## SUNDRY NOTICES AND REPORTS ON WELLS

North Indian Basin #7  
Unit

30-015-20089

RE: Plugging and Abandonment Requirements, Conditions of Approval

**OXY USA WTP LP - Proposed  
North Indian Basin Unit #7  
API No. 30-015-20089**

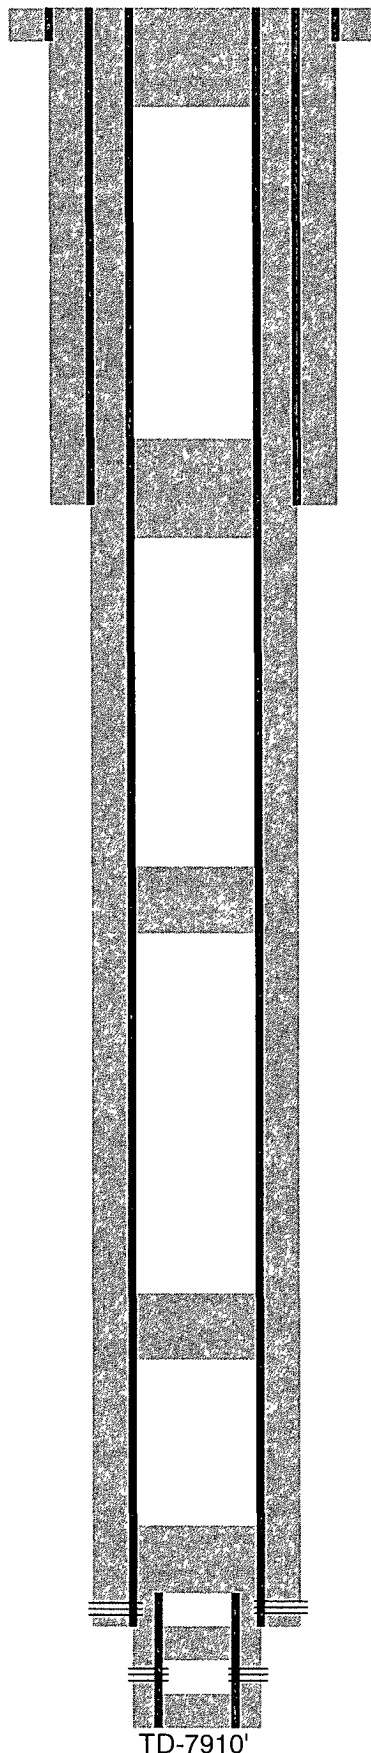
1. Change – Spot a plug from 7880'-7700': WOC and tag at 7700' or shallower. (Perfs)
2. Change – Spot a plug from 7645'-7385': WOC and tag at 7385' or shallower.  
(Perfs – Casing Shoe – Liner Top – Upper Penn)  
OPTIONAL – Combine steps 1 & 2 into a single plug.
3. OK (Wolfcamp)
4. Change – Spot plug from 3620'-3480'. (Bone Springs)
5. OK (Casing Shoe – Glorietta)
6. Spot plug from 400' to surface – Otherwise OK (Casing shoe – Surface)
7. Submit a subsequent report to the BLM.
